Proposal #42: 1500-48-60, WISC 2022397
Waupaca-Menasha
NCL-STH 441
USH 10
Winnebago County

This is Addendum No. 01, which provides for the following:

Addendum No. 01
ID 1500-48-60
Added Sheet 8A
April 28, 2022

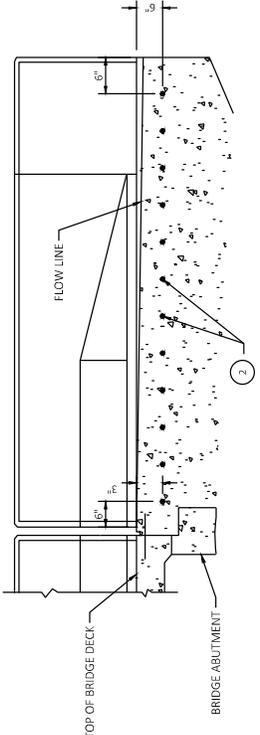
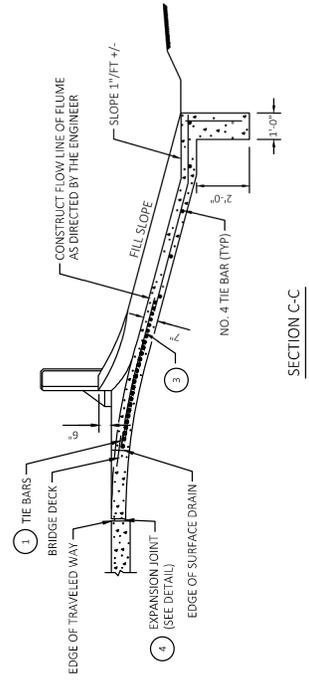
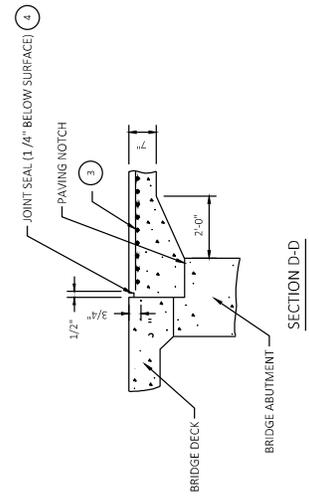
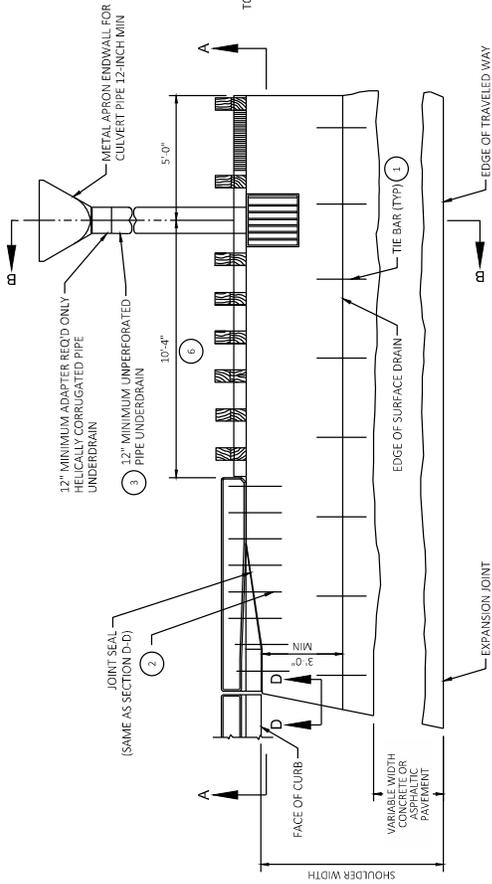
Added Plan Sheets	
Plan Sheet	Plan Sheet Title (brief description of why sheet was added)
8A	Construction Details – Concrete Surface Drain without Pipe at Structures
8B	Construction Details – Concrete Surface Drain Drop Inlet Type
